City of Lake Elmo Planning Department  
**PUD Concept Plan Review**

---

**To: City Council**

Re: The Royal Golf Club at Lake Elmo  
Concept Plan Review

**Structures /  
Builders:**

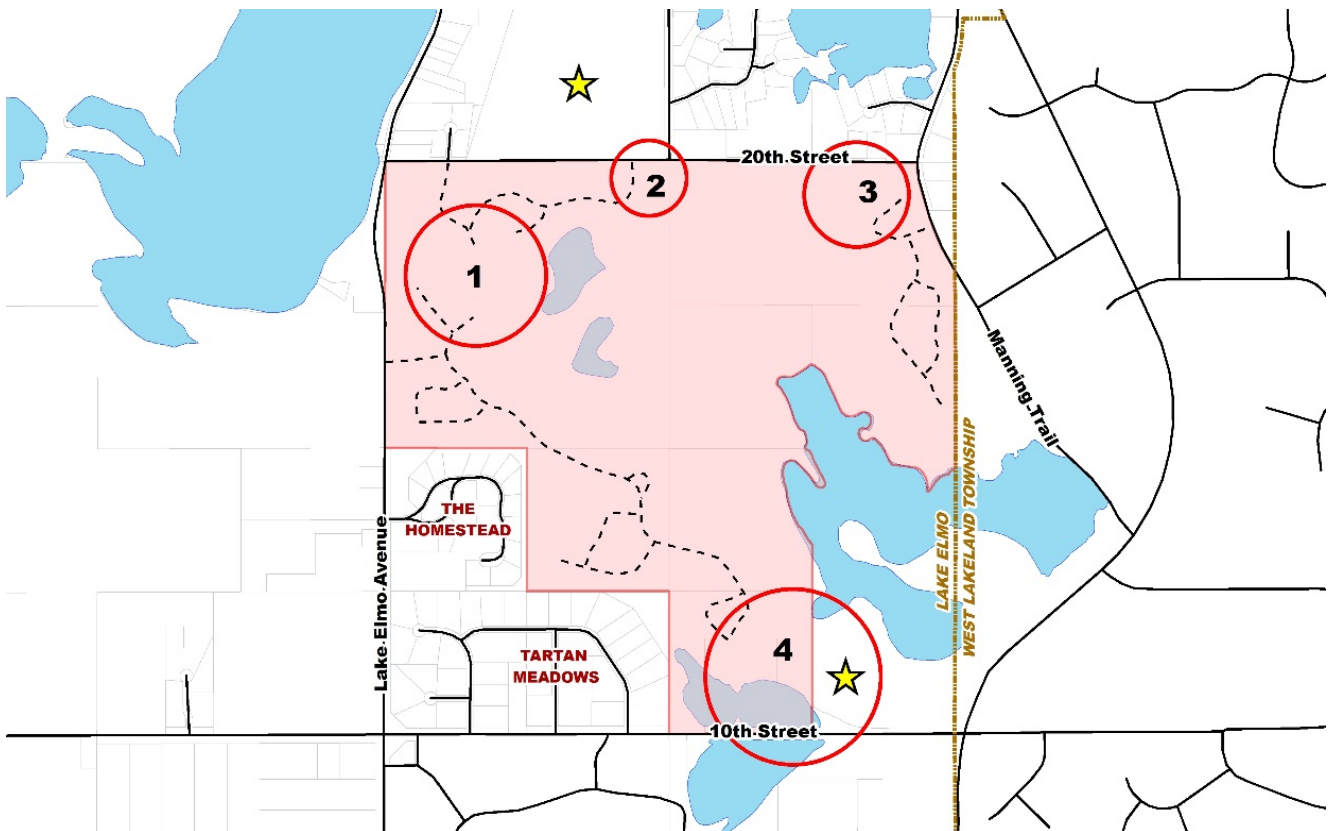
**Staff comment:** Moving forward, the applicant should be prepared to provide elevation drawing examples of the various product types so Council, the Commission, and public know what can be expected in the various portions of the proposed development.

#### MUNICIPAL SANITARY SEWER

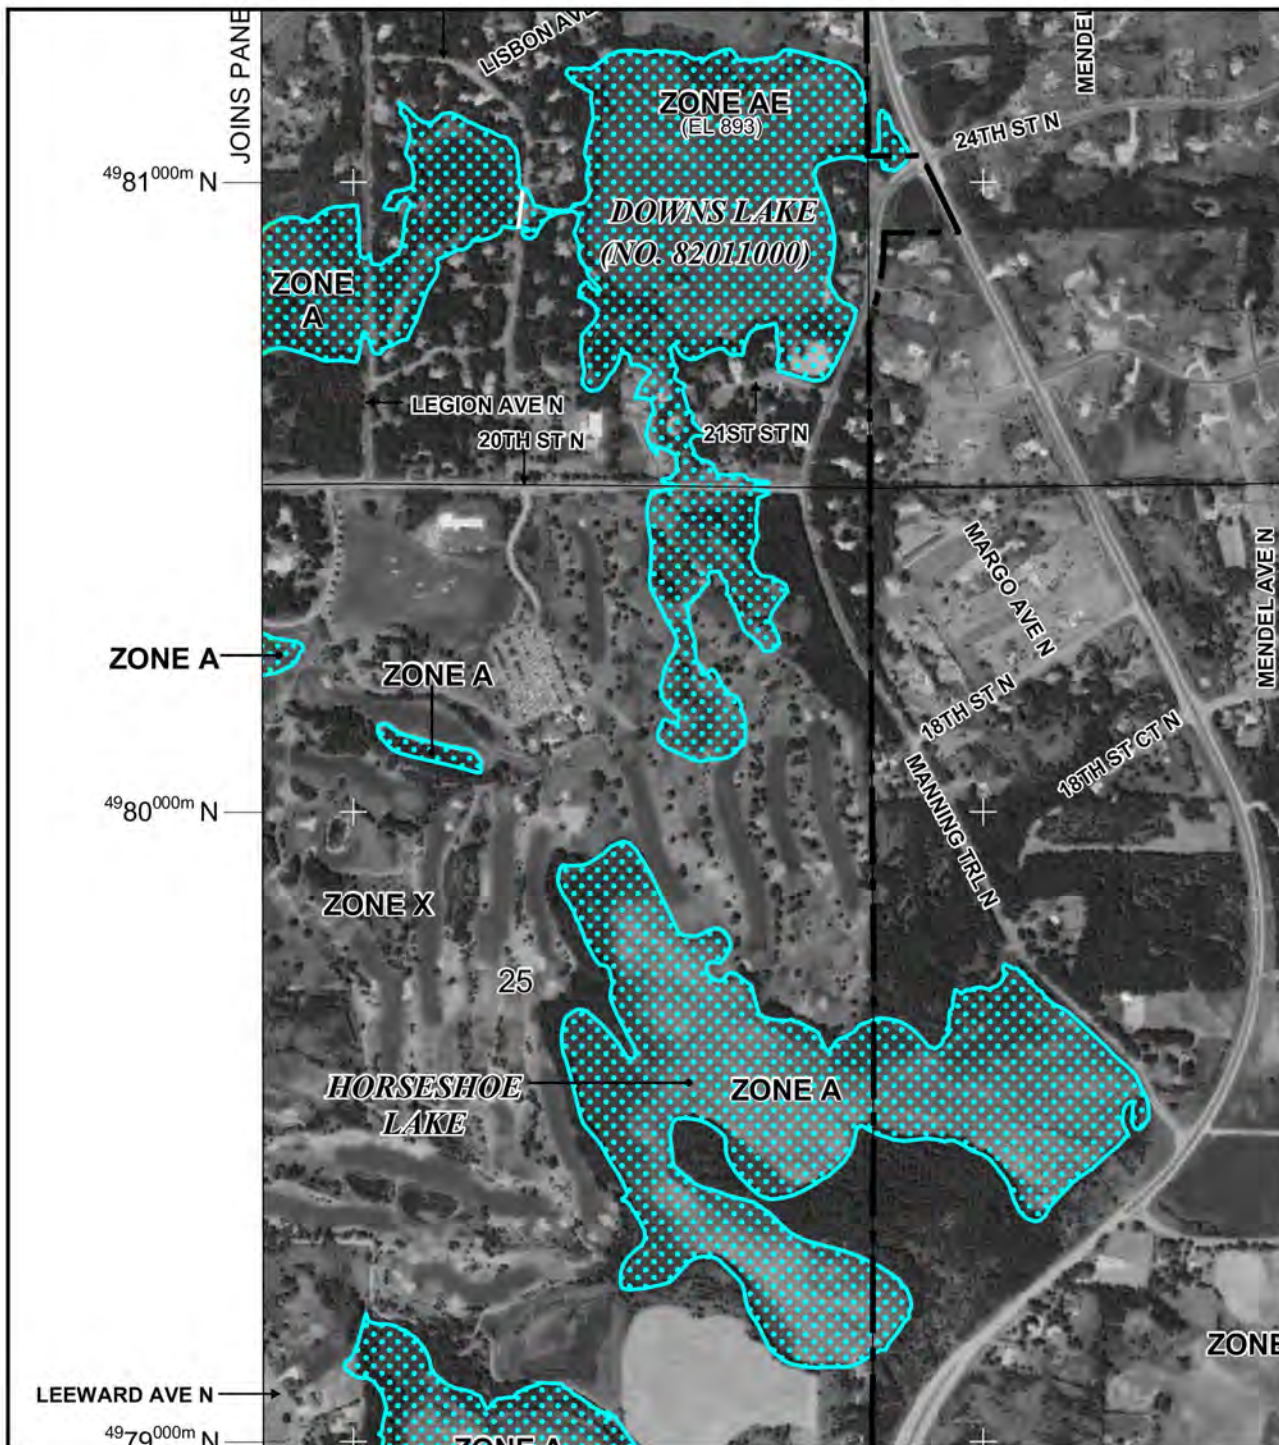
- The applicant is responsible to provide wastewater infrastructure to support the proposed development. All sewer infrastructure must be provided at the developer's cost.

- The application and sketch plans do not address sanitary sewer service. However, it is staff's understanding that it is intended for the development to be served by municipal sewer.

**Structures / Builders:** ***Applicant Comments on Builders:** Builders for the development have not been chosen. Presently we are considering a pool of 5-7 custom builders for the traditional homes and 2 custom home builders for the villa product.*

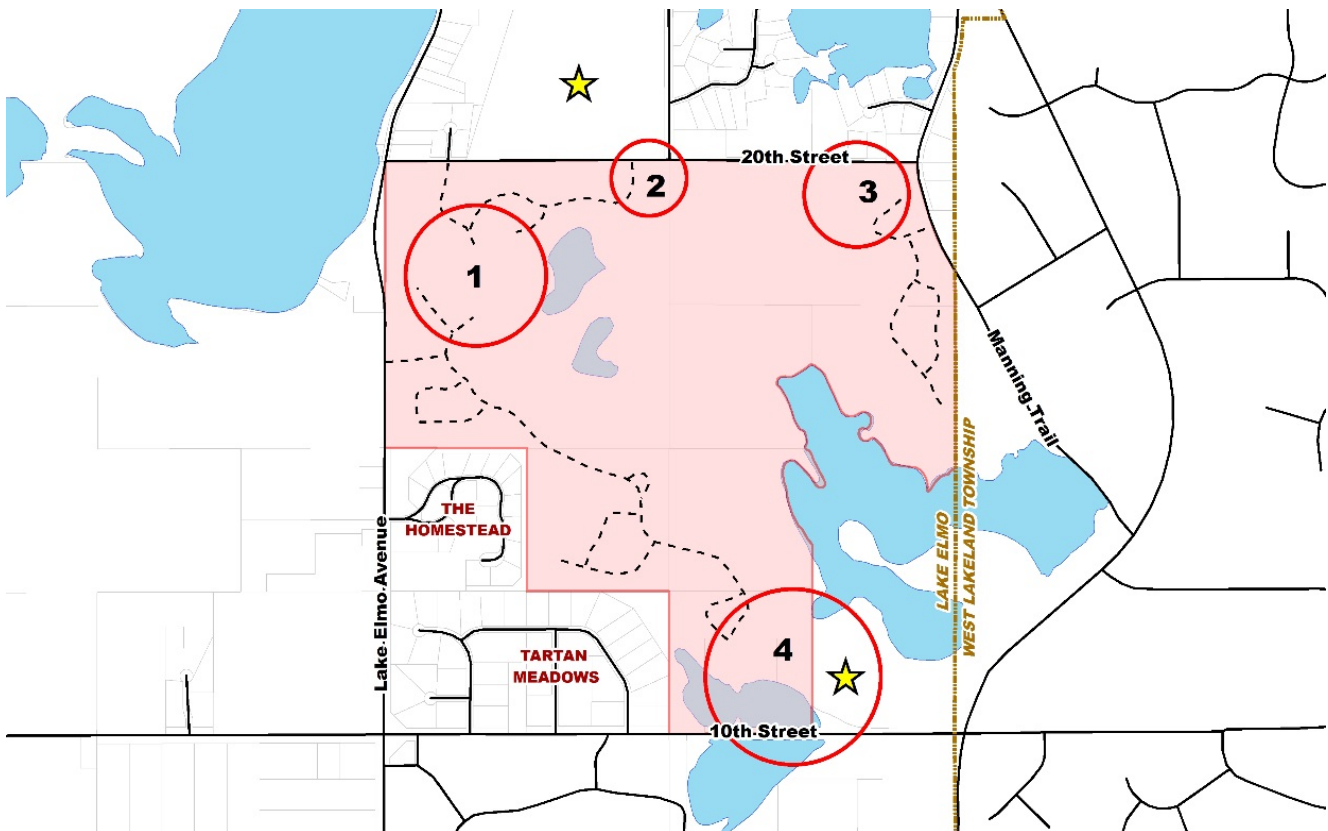
**Staff comment:** Moving forward, the applicant should be prepared to provide elevation drawing examples of the various product types so Council, the Commission, and public know what can be expected in the various portions of the proposed development.

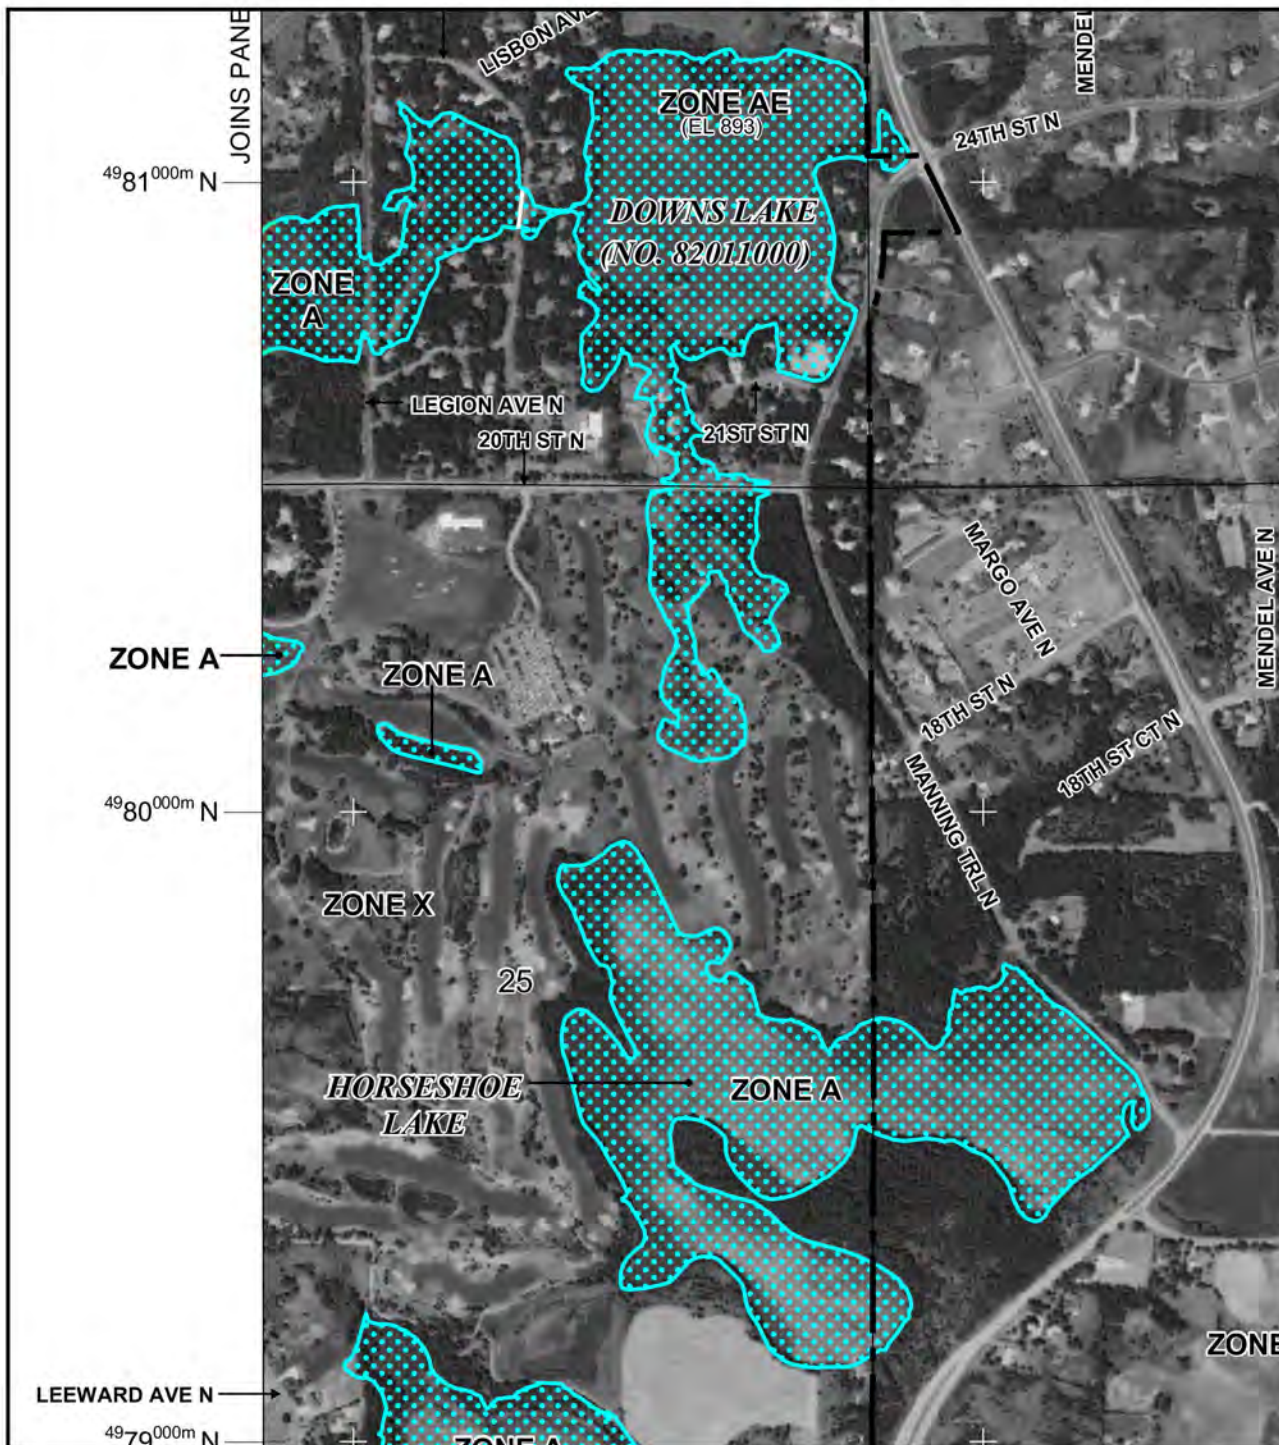
- Sewer service could be provided by constructing a lift station at the south end of Tartan Park with a forcemain constructed along 10<sup>th</sup> Street N. to connect to the existing 16-inch forcemain along Lake Elmo Avenue. The sewer system should be designed so that the 10<sup>th</sup> Street lift station can be eliminated in the future when gravity sanitary sewer is extended to serve Cimarron and Oakland Junior High School.

- Interior to the development multiple lift stations may be required due to the varied topography of the property. The sewer system must be designed City standards and must minimize lift stations and future ongoing operational costs.
